Response to: Adequacy Review, 110(1) Hardrock Application, Quist Mining, File No. M-2023-002

Extension granted April 10, 2023) on 110(1) Hardrock Application, Quist Mining, File No. M-2023-002

* See Four-Three point crosssection example

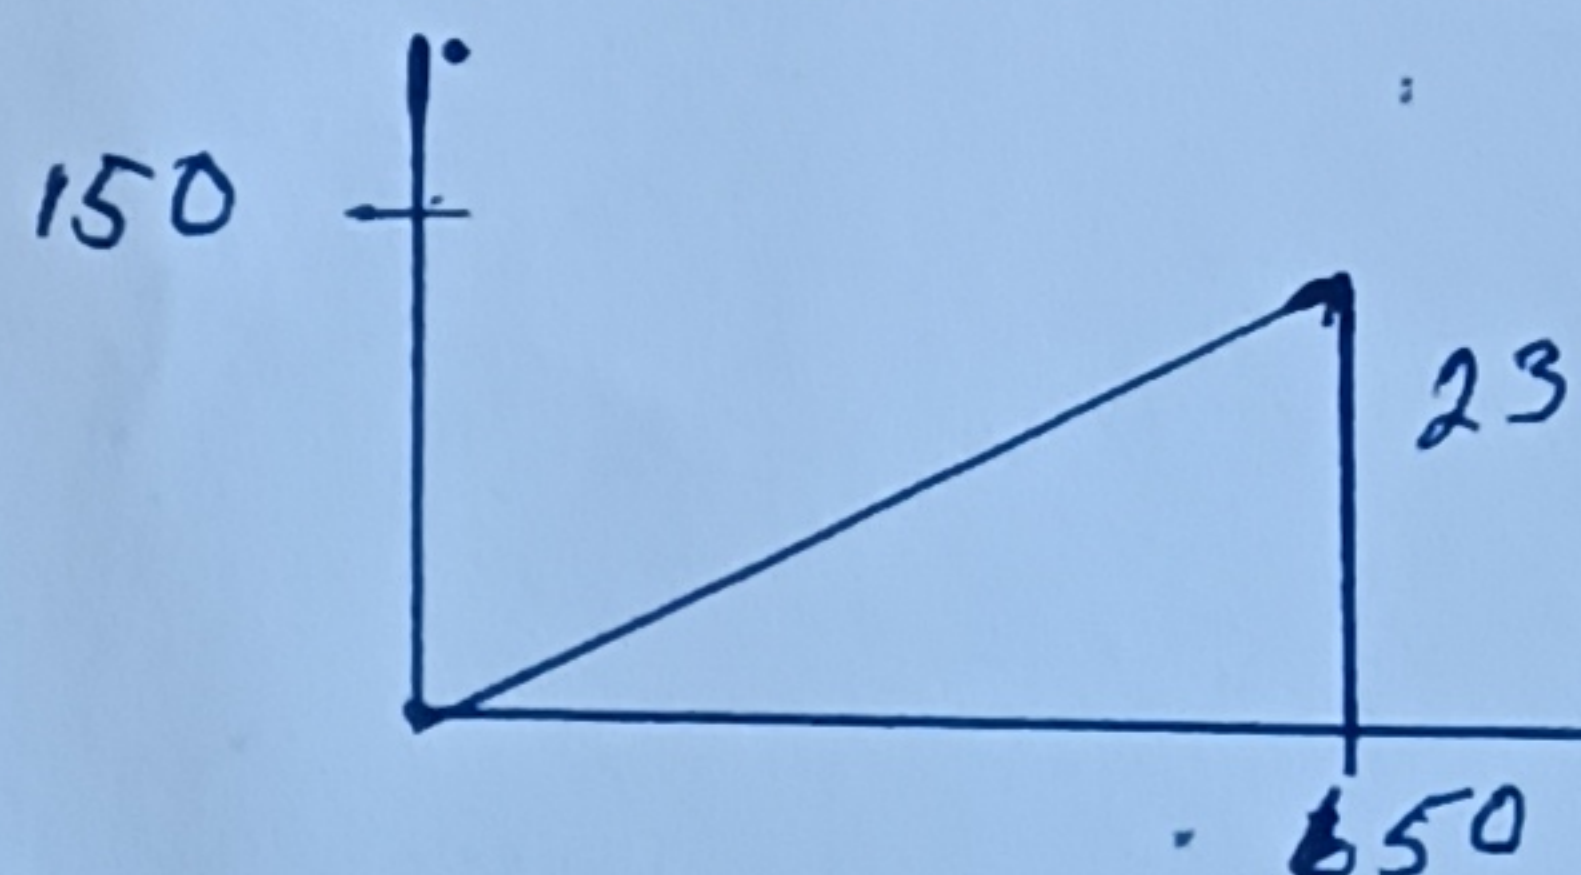
3) What will the final grade of the reclaimed slopes (Horizontal:Vertical): 4.3 H: 1 V

Final grades will be same as original slope which is
650' run to 150' rise 23° (Run=650' Rise=150')

Four & THREE POINT Cross section Example

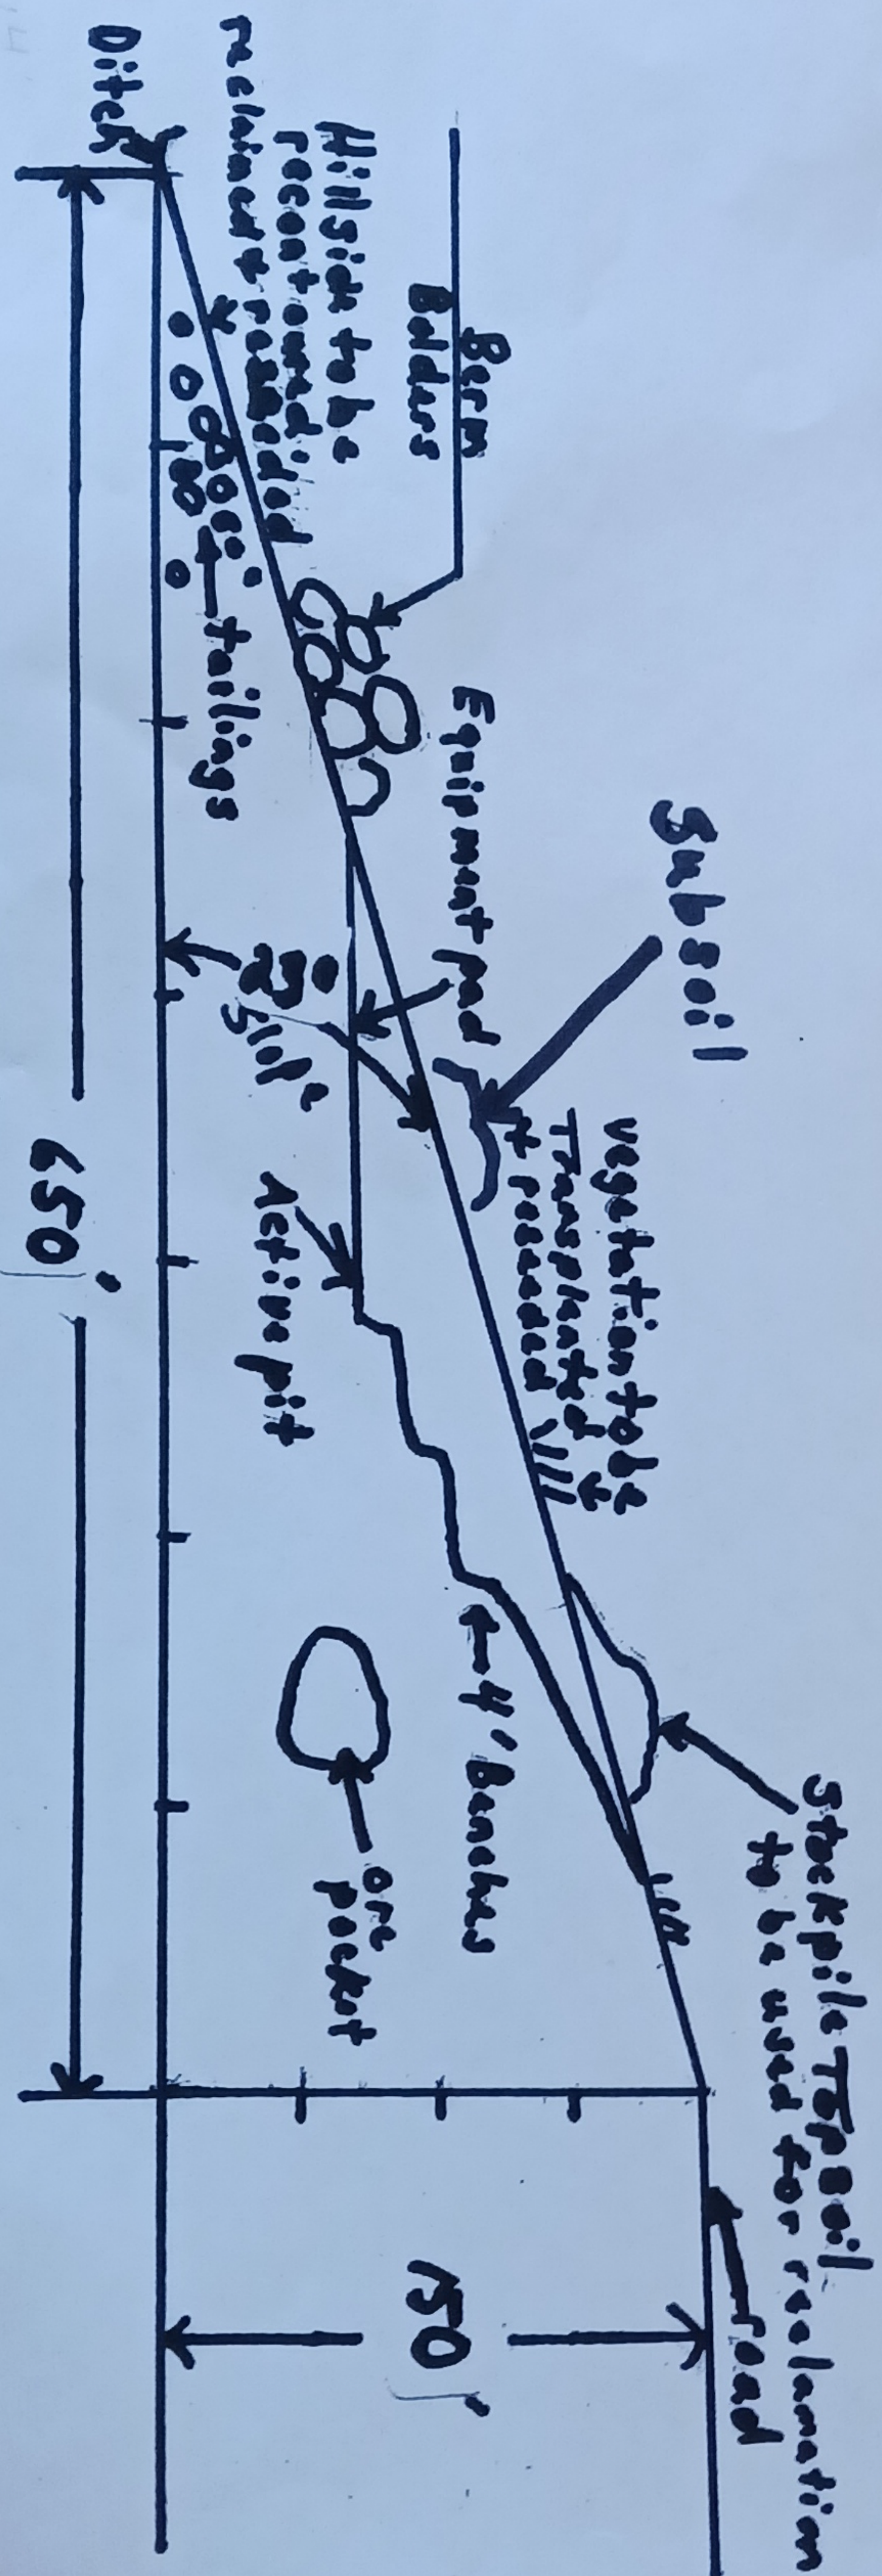
2. The Cross Section Reclamation Plan Map has been corrected to reflect the 4-6 inches of topsoil and 8 inches of subsoil to be replaced and is attached to this application.

4-6"
and
8" Subsoil
(12-14" Total)
Total 4-6"

Topsoil will be used to contour the site
Reclamation will return to existing slope & be needed
